Re: 327 N. Corry MUP

From: Jacob Patterson <jacob.patterson.esq@gmail.com>
Sent: Thursday, April 08, 2021 11:30 AM
To: Locke Kevin
Cc: Gonzalez, Joanna
Subject: Public Comment -- MUP 3-21
Attachments: Second Story ADU - 321 S. Whipple and 208 Park Street.pdf

208 Park Street

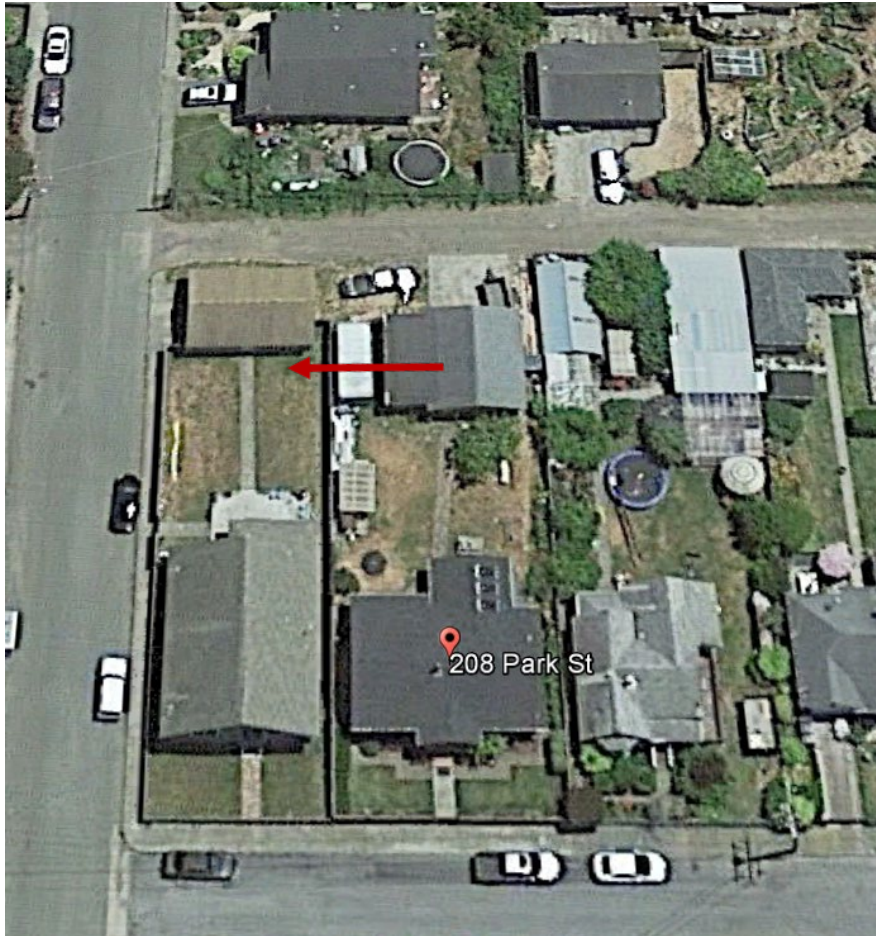
See the attached window analysis from two recent second story ADU MUP applications. This type of visual analysis is missing from the staff report and agenda materials for MUP 3-21. In light of the staff recommendation to further shift the proposed second story ADU eastward five additional feet from the location proposed by the applicant in response to neighborhood compatibility concerns raised in the written request for a public hearing, this type of "neighboring yard" window placement analysis is even more necessary for the review for MUP 3-21 to evaluate the window placement for the northern and southern elevations of the proposed second story ADU. I recommend that it be prepared and presented during the administrative public hearing to ensure that no windows directly overlook any of the rear or side yard areas on the neighboring lots.

Staff determined window placement looked directly into neighboring yard

Staff determined windows looked directly onto roof of neighboring structure to south, and parking area to the north
